One Victoria,

Great Ducie Street,
Manchester

Proposed Amendments

Comparative Drawing Study

West Elevation - DAY Amendment

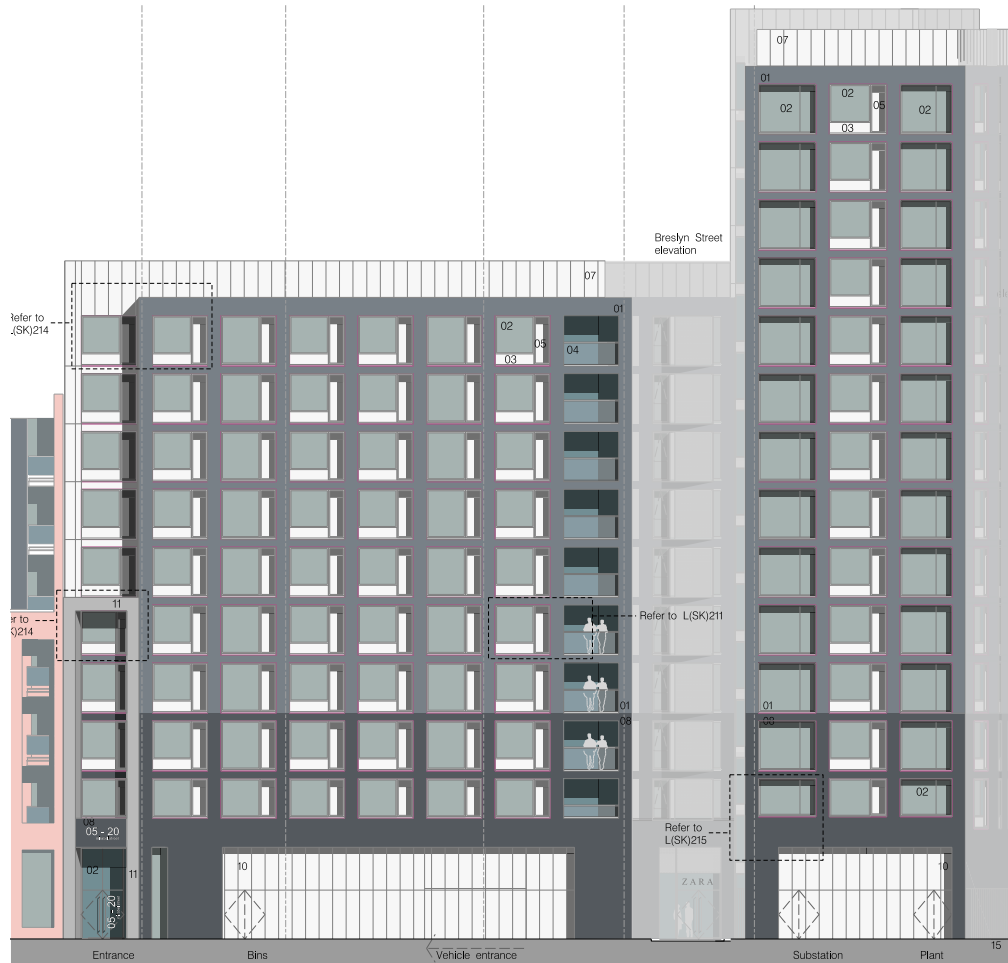
- A Plant screen omitted
- B Changed to full height opener with transom glazed ballustrade
- C Window omitted
- D Louvred screen to sub station as Energy providers' requirements
- E Perforated apertures instead of louvres

South West Elevation - DAY Amendments

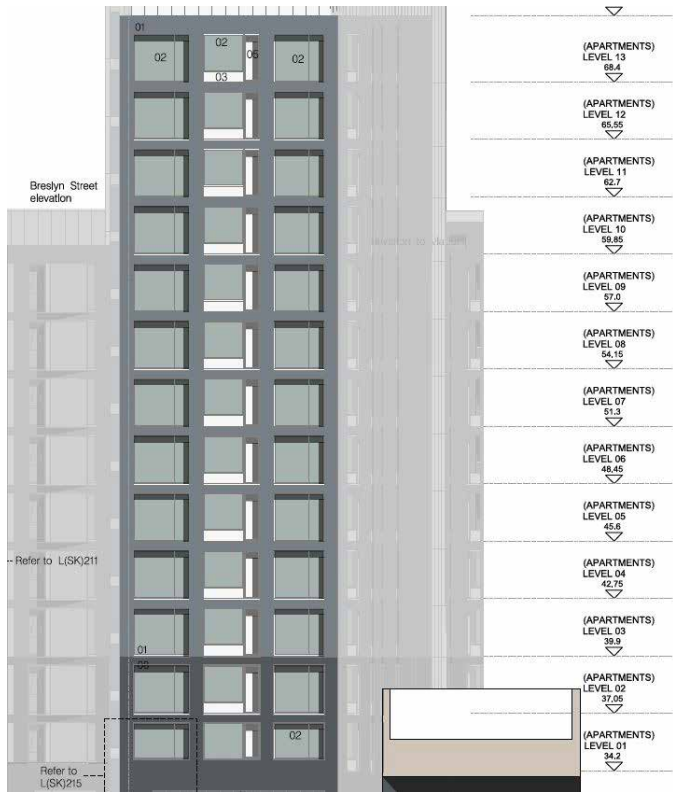
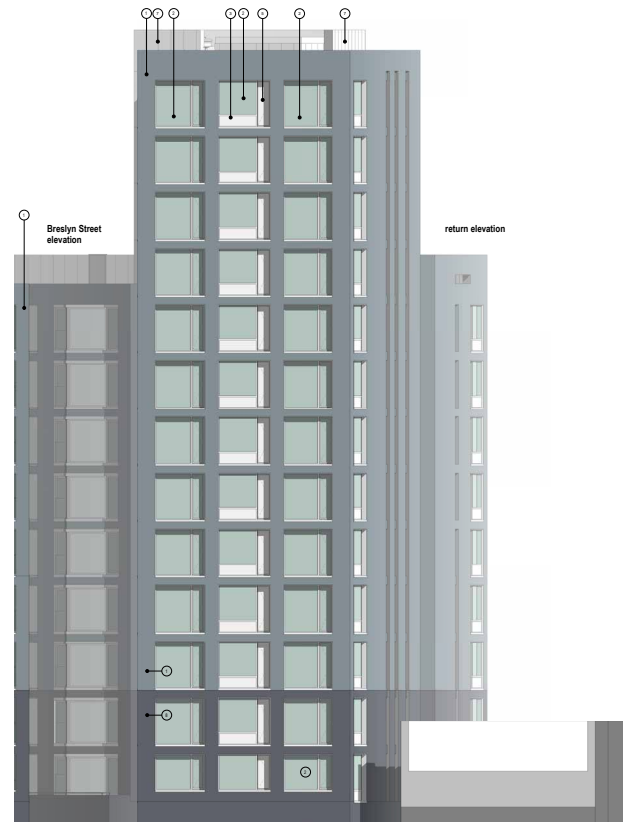
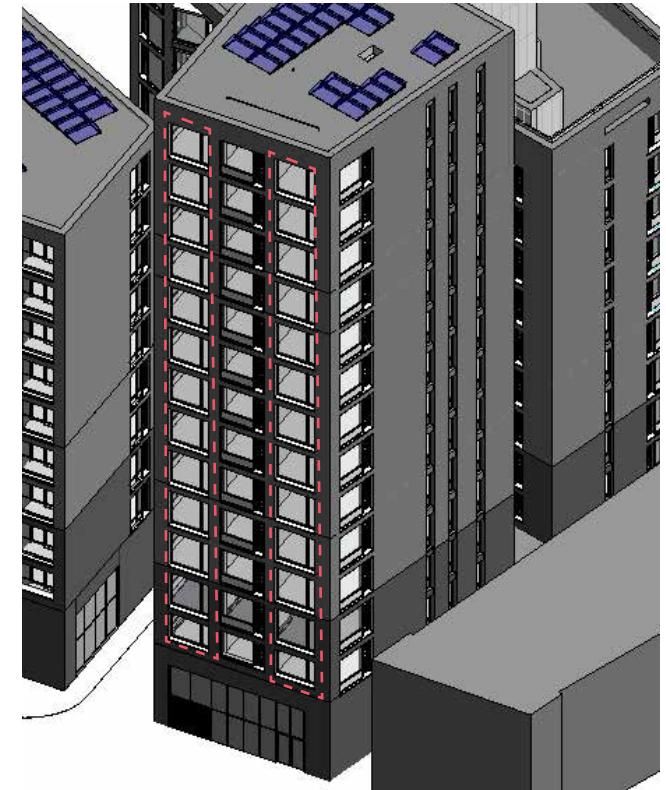
Due to the location of the apartment living spaces on the south west elevation, these rooms are subject to increased solar gain and high levels of occupation during the evening sun hours. The Mechanical Engineer has requested that the windows highlighted on the proposed elevation are updated to include an opener to the smaller element of glazing.

Gable End Elevation - DAY Amendments

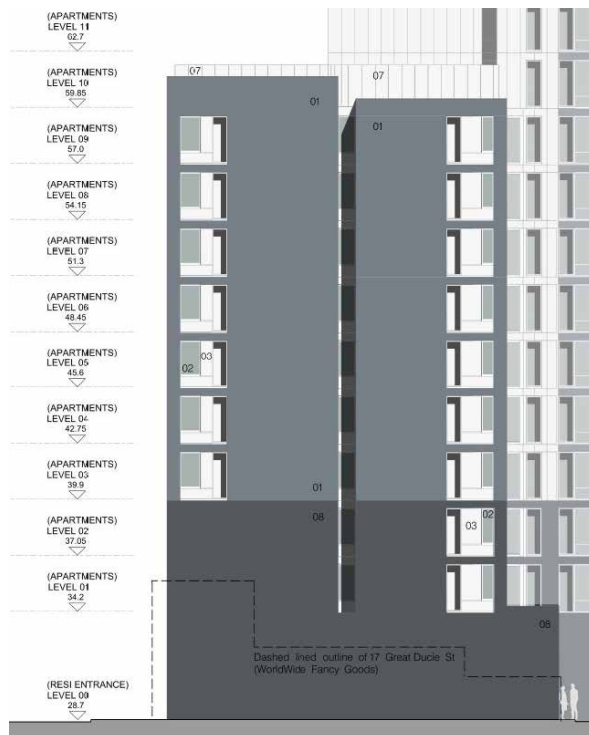
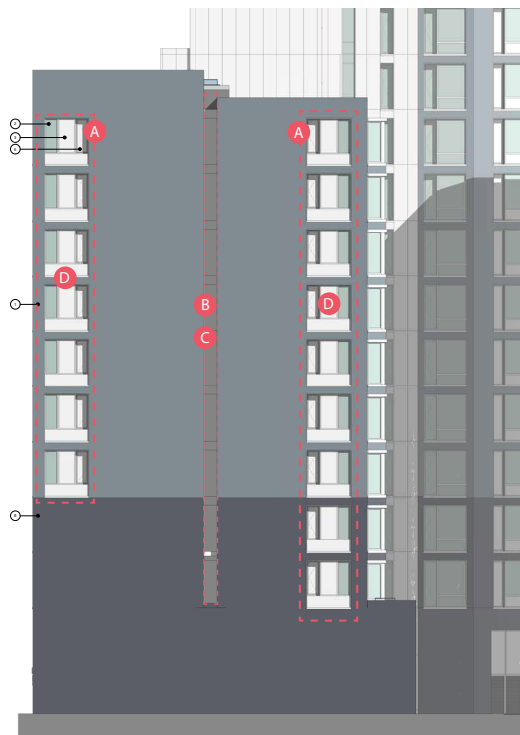
- A Window style to gable end amended to allow for 1m sq opening in line with fire regulations
- B Width of split in facade reduced to 685mm (from 900mm) to align with brick dimensions
- C Changed to aluminium cladding system. This is due to the requirement for a mechanical smoke shaft
- D Where the building is to be constructed close to the boundary the large areas of glazing present a fire risk, as such the window types have been updated to provide a 1m sq opening window in line with fire regulations

Where the building is to be constructed close to the boundary line the large areas of glazing present a fire risk to neighbouring buildings. In order to comply with fire regulations the window type has been updated to provide a smaller opening window (less than 1m sq). The remainder of the window is to be opaque glazed with a fire rated wall constructed to the rear of the window.

Detail Section C-C 1:100

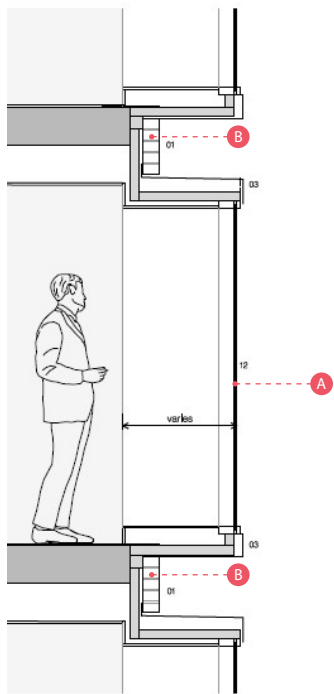
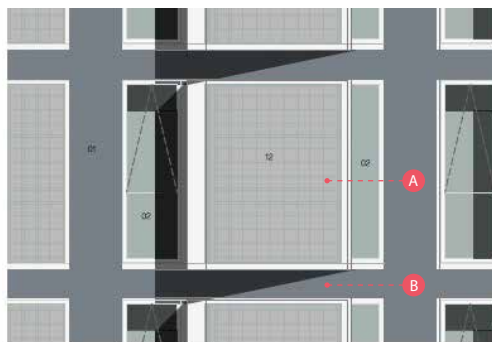
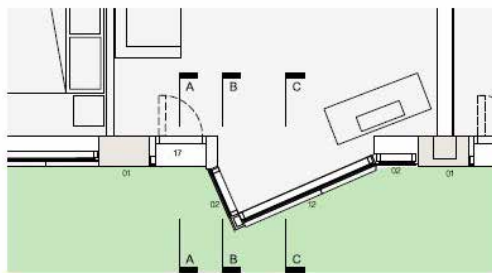
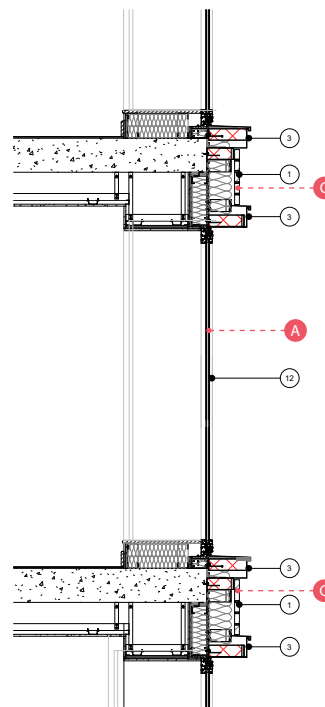
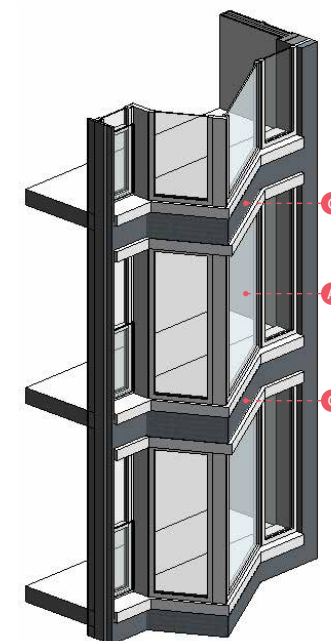
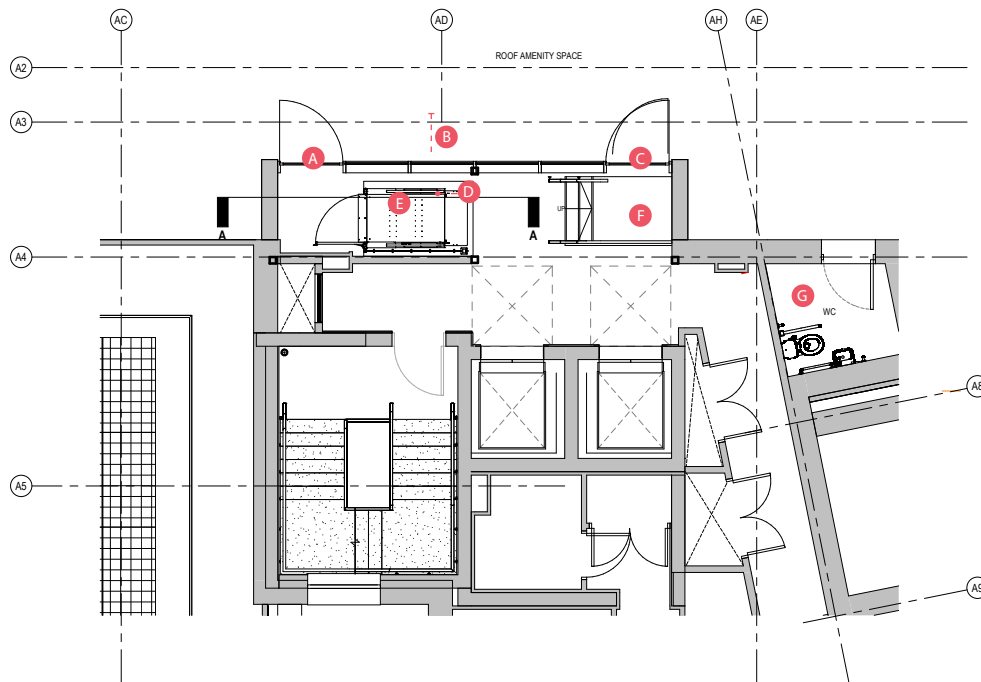
- A Window profile and sight lines retained
- B Feature recess between head and base of adjacent sawtooth windows shown with minimal construction zones. This is not feasible to build with recent changes to fire legislation.
- C Recess to head and soffit of feature windows omitted. Masonry to follow line of window

The detail of these windows presents several issues for construction and maintenance. The intent for the original approved planning scheme is to include masonry within a narrow recess to the head/ base of these windows whilst maintaining a slim profile to the head and base of the sawtooth profiled windows as shown in section C-C. Having undertaken several design reviews we have concluded that the detail and key sight lines as originally proposed is not feasible due to recent changes in fire regulations alongside thermal performance upgrades (as listed under

the Approved Document Part B, regulation 7(2) and Approved Document Part L). In order to maintain key sight lines it is proposed that the recess between the base and head of the feature windows is to be removed in favour of masonry to follow the profile of the window. The window profiles are to be retained to preserve the sight lines as originally proposed. Where windows are required for purge ventilation a glazed balustrade will be provided.

10 - Level 10 Amenity Ramp Sketch - Option 03

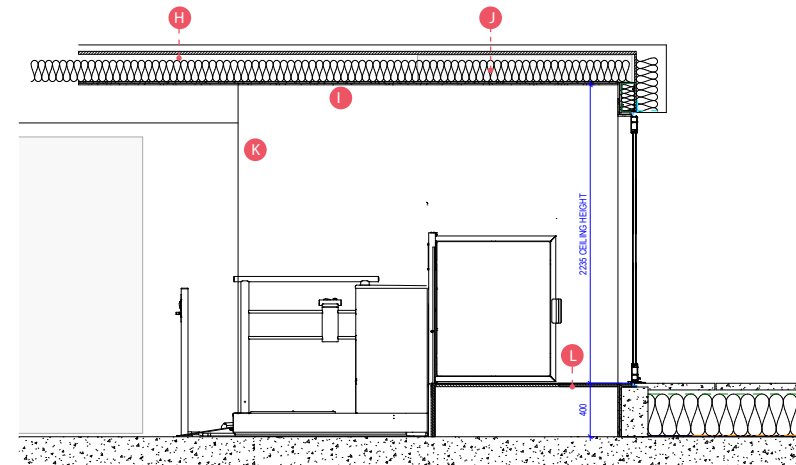
- A Additional door
- B Entrance lobby extended
- C 21m from north west corner of amenity space / maximum travel distance
- D Lightweight steel/ rainscreen feature surround (original location shown dotted)
- E Access platform to provide access to roof
- F Stepped access to roof terrace
- G Floor raised to around 450mm above SSL for WC
- H Details of roof structure and canopy in abeyance
- I Roof structure shown indicative only
- J Steels within roof structure set to align with slab level
- K Door to platform lift on landing shown open
- L Raised floor to meet level of roof

Proposed amendments to the interior amenity space with the introduction of a platform lift at the rear exit negotiating the miss-aligned floor levels between the interior foyer and external FFL.

One Victoria and Worldwide Fancy Goods Interface

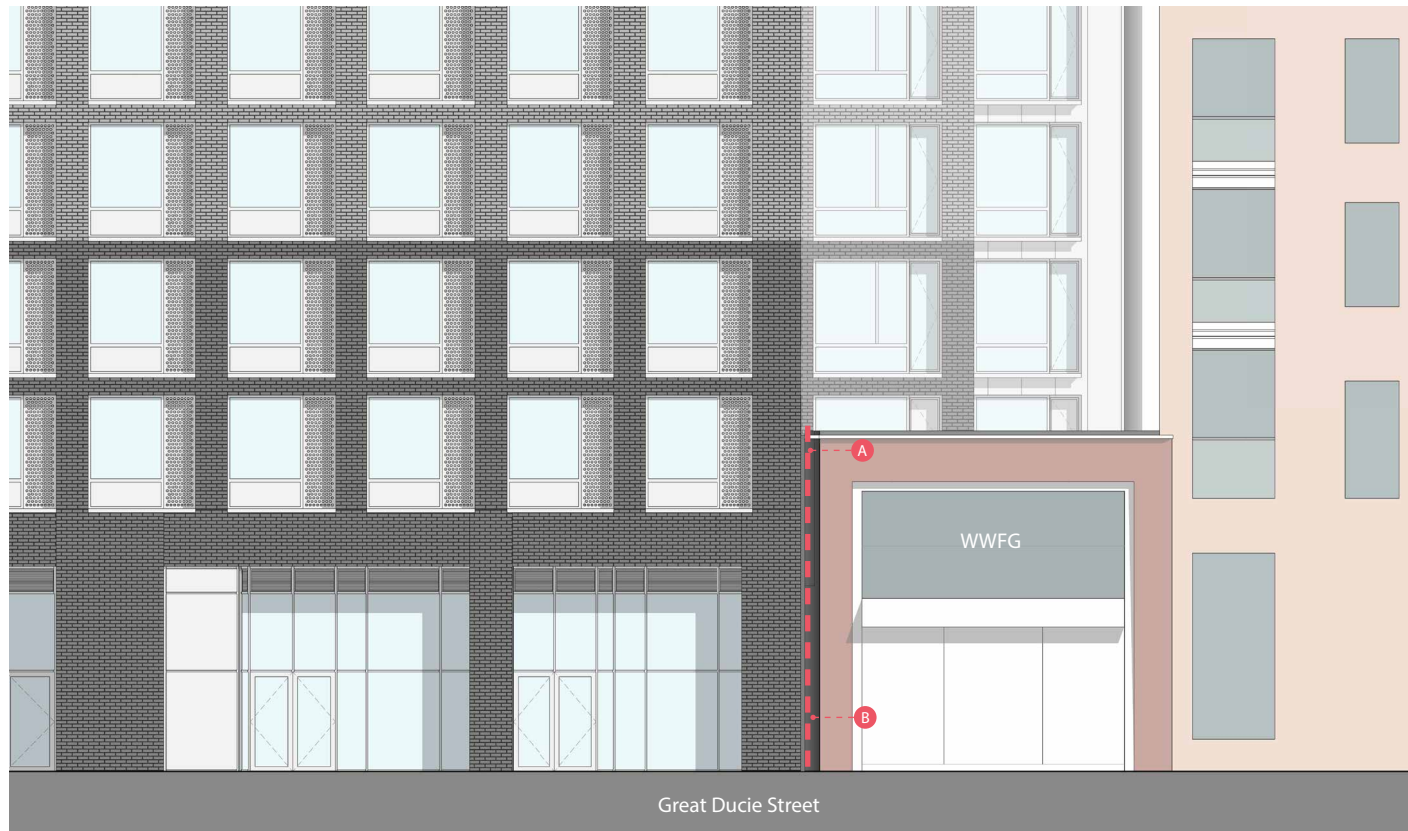
- A Opening closed with masonry to match main building
- B Movement Joint

The joint against the Worldwide Fancy Goods building and One Victoria will be closed with recessed masonry to match the main building. This will be agreed as part of the Party Wall Agreement.
